EMP Assessment Report – Hi-Quality (Bulla)

Publication 1942.1 March 2021

Environment Protection Authority Victoria (EPA) received from Hi-Quality Sales Victoria Pty Limited (Hi-Quality) an Environment Management Plan (EMP) application proposing to receive and manage soil and rock (spoil) generated from the West Gate Tunnel Project (WGTP). This followed a series of technical documents submitted over previous weeks. In addition, EPA received a sample analysis quality plan from CPB/John Holland Joint Venture (CPBJH JV).

Figure 16: Plan of the holding bay area and leachate management area (option 1) (from EMP Appendix C)

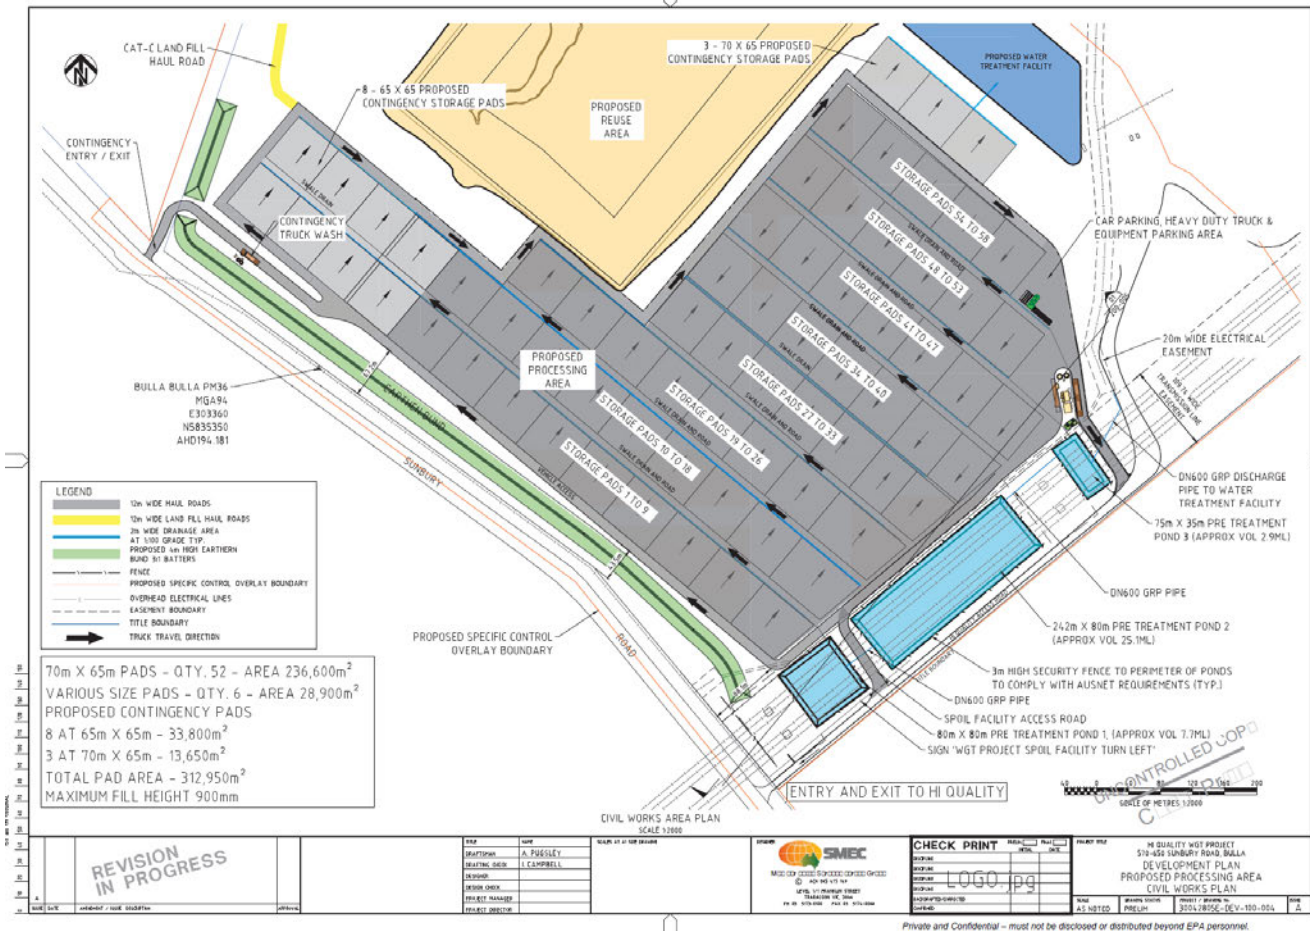
The concept plans for the holding bay area are provided in the EMP (Appendix A of Appendix C of the EMP and Figure 16 of this report). These detail the location and arrangement of the individual holding bays, leachate collection system, leachate conveyance pipes, leachate storage ponds, internal access roads, weighbridge and wheel washes.

The provided maps, plans and indicative design drawings, broadly meet many of the relevant components detailed in Appendix 9 of EPA Publication 1323.3, which is applied to waste containment cells. The provided information demonstrates the design can effectively manage the spoil during short term storage and allow direction of generated leachate to leachate management infrastructure. It is noted that further detailed design drawings will be required to be prepared for construction, detailing the subgrade levels and liner component plans. The Performance Specification states that final design drawings will be prepared, including 3D surface models, in general accordance with Appendix 9 of EPA Publication 1323.3. This is appropriate guidance to follow and if prepared in accordance with the information in the EMP will meet the design intent.

Figure 18: Liner profile for the holding bay (Appendix A of the Technical Specifications in Appendix C of the EMP)

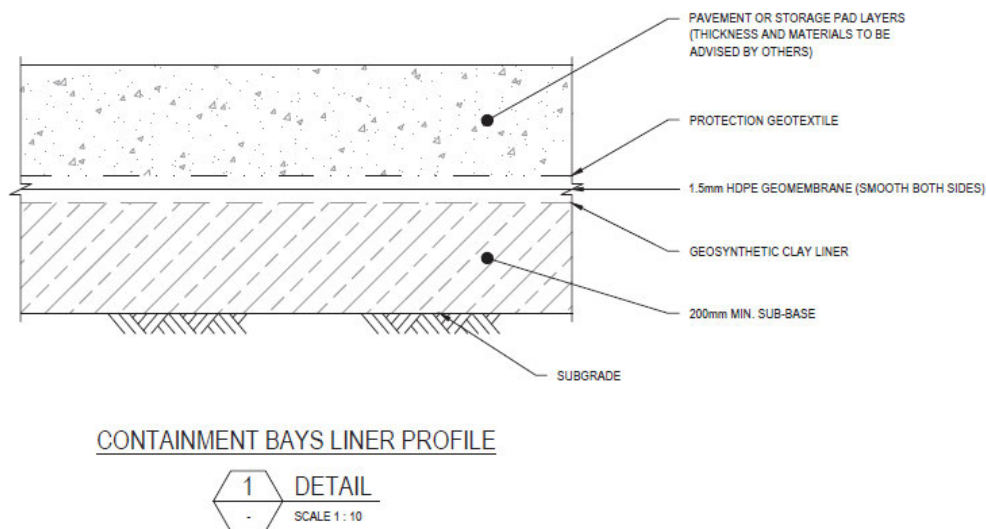
The proposed liner underlying the holding bays, their associated haul roads and leachate management system, is for a composite liner, with both a geomembrane and a GCL. The liner profile is detailed in the EMP and provided in Figure 18, consisting of (from top to bottom):

This is consistent with a Type 2 landfill liner as per EPA Publication 788.3 and has multiple layers in the case of failure of one of the components. In addition, the sub-base layer has similar properties to that of clay material used in liner construction and may, therefore, further limit seepage and contaminant transport. The liner performance in relation to the key contaminants of concern (PFAS) is considered as part of the hydrogeological risk assessment, which used numerical modelling to support the use of the liner (see section 6.5). This indicates that the proposed liner can sufficiently protect groundwater beneficial uses directly below the infrastructure, during the project even given conservative assumptions.

Figure 19: Indicative design drawings of the basal liner (1) and sidewall liner (2) (from Appendix E of the EMP)

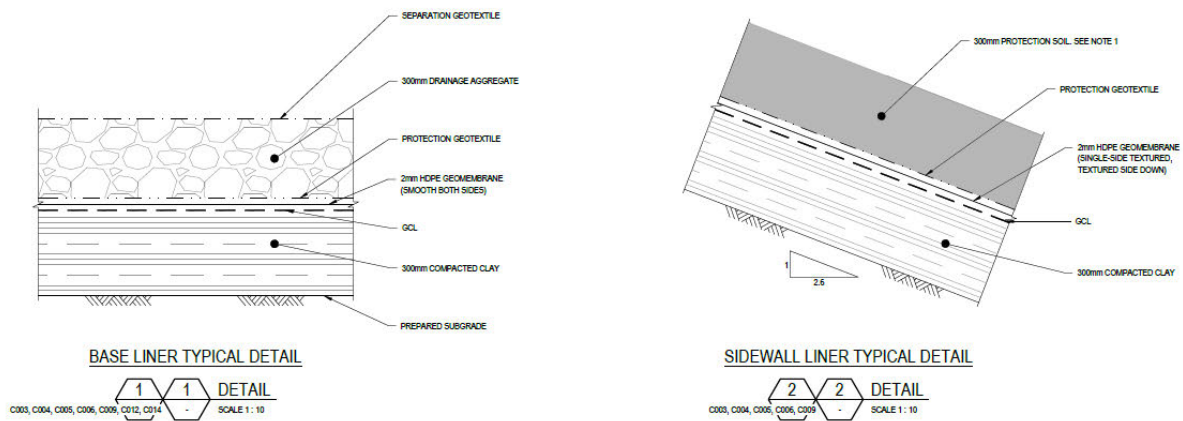
The maps and plans appear to confirm the cell is designed in line with requirements typically applied to Type 2 landfill cells as per EPA Publication 788.3. Key deviations from EPA Publication 788.3 include the spacing of the leachate collection pipes, discussed further in section 7.2.1.4 of this report.

In conclusion, the maps and designs broadly indicate that the design meets the design objectives and that the cell can adequately manage environmental risks. This is also reliant on the additional design aspects addressed in the Design Report, Technical Specifications and the CQA Plan.

The liner profile adopted for the containment cell base and sidewall are provided here in Figure 19: Indicative design drawings of the basal liner (1) and sidewall liner (2) (from Appendix E of the EMP). The cell base liner consists of (from top to bottom):

Figure 20: Indicative pre-treatment pond plan and cross section (Attachment 4 of EMP Appendix D)

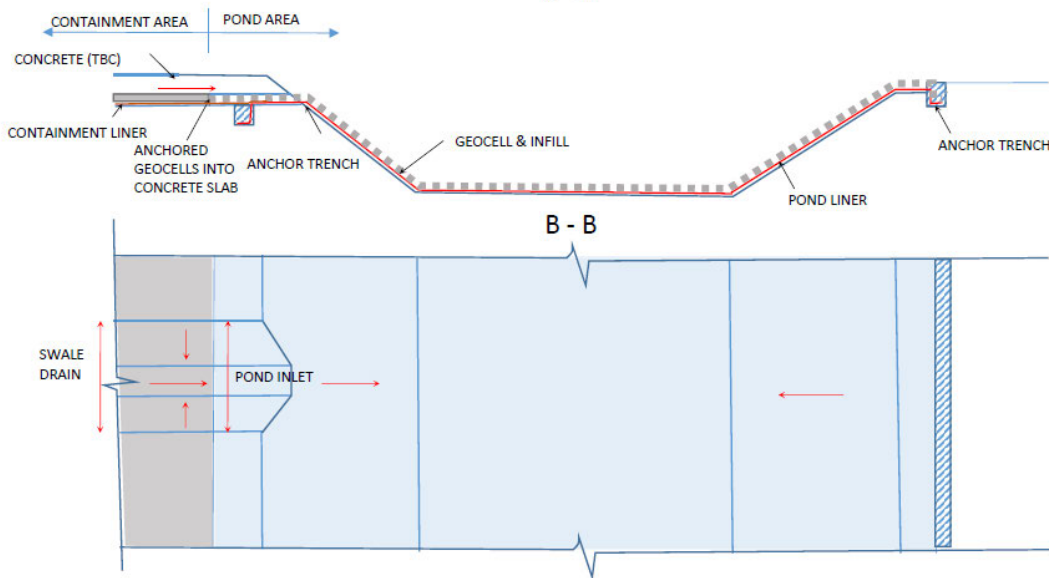
Indicative design drawings for the pre-treatment ponds are provided in the EMP (Attachment 4 of EMP Appendix D). These include a cross section and plan of an indicate pre-treatment leachate pond (Figure 20). In addition, the pre-treatment pond liner profile and anchor trench are provided in Appendix A of the Technical Specifications (Appendix C of the EMP).

The provided maps, plans and indicative design drawings, broadly meet many of the relevant components detailed in Appendix 9 of EPA Publication 1323.3. The provided design drawings for the ponds are limited in detail, however, the Performance Specifications, Technical Specifications and CQAP together address the key environmental protection objectives of the leachate pond. The Performance Specification states that final design drawings will be prepared, including 3D surface models, in general accordance with Appendix 9 of EPA Publication 1323.3. This is appropriate guidance to follow and if prepared in accordance with the information in the EMP will meet the design intent.

Figure 21: Liner profile for the pre-treatment leachate pond (Appendix A of the Technical Specifications in Appendix C of the EMP)

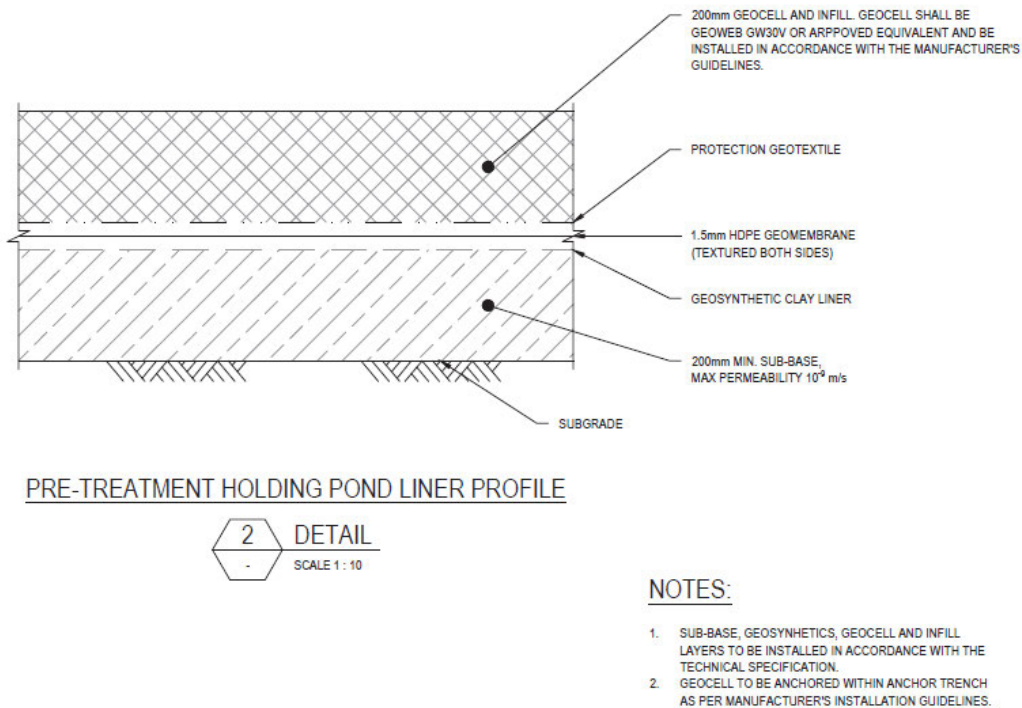
The proposed liner for the pre-treatment leachate ponds is for a composite liner, with both a geomembrane and a GCL, in addition to a further 200 mm compacted clay sub-base layer. The liner profile is detailed in the EMP and provided in Figure 18, composed of (from top to bottom):

This is consistent with a Type 2 landfill liner as per EPA Publication 788.3 and has multiple layers in the case of failure of one of the components. The liner performance in relation to the key contaminants of concern (PFAS) is considered as part of the hydrogeological risk assessment, which used numerical modelling to support the use of the liner (see section 6.5). This indicates that the proposed liner can sufficiently protect groundwater beneficial uses directly below the infrastructure, during the project even given conservative assumptions.

The geocell provides confinement and protection of the liner components. The specifications and quality control processes, for the geocell and infill are addressed in the Technical Specifications (section 10). These adequately address the use of this material for this application.

Figure 22: Leachate management system for the containment cell and the holding bays (diagram from Appendix D of the EMP)

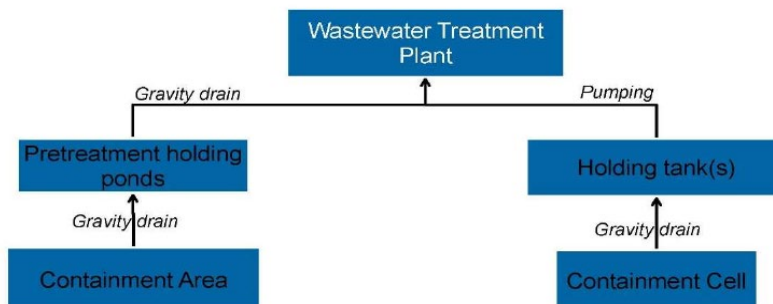
The provided leachate balance considers leachate generated in the containment cell and holding bay area (see Figure 22 for schematic). The holding bays water balance considers the designs for the holding bays (as detailed in section 7.1). The water balance informs the sizing of the leachate holding tank for the containment cell and the pre-treatment leachate ponds. The WTP is assumed to have a capacity of 3 ML a day.
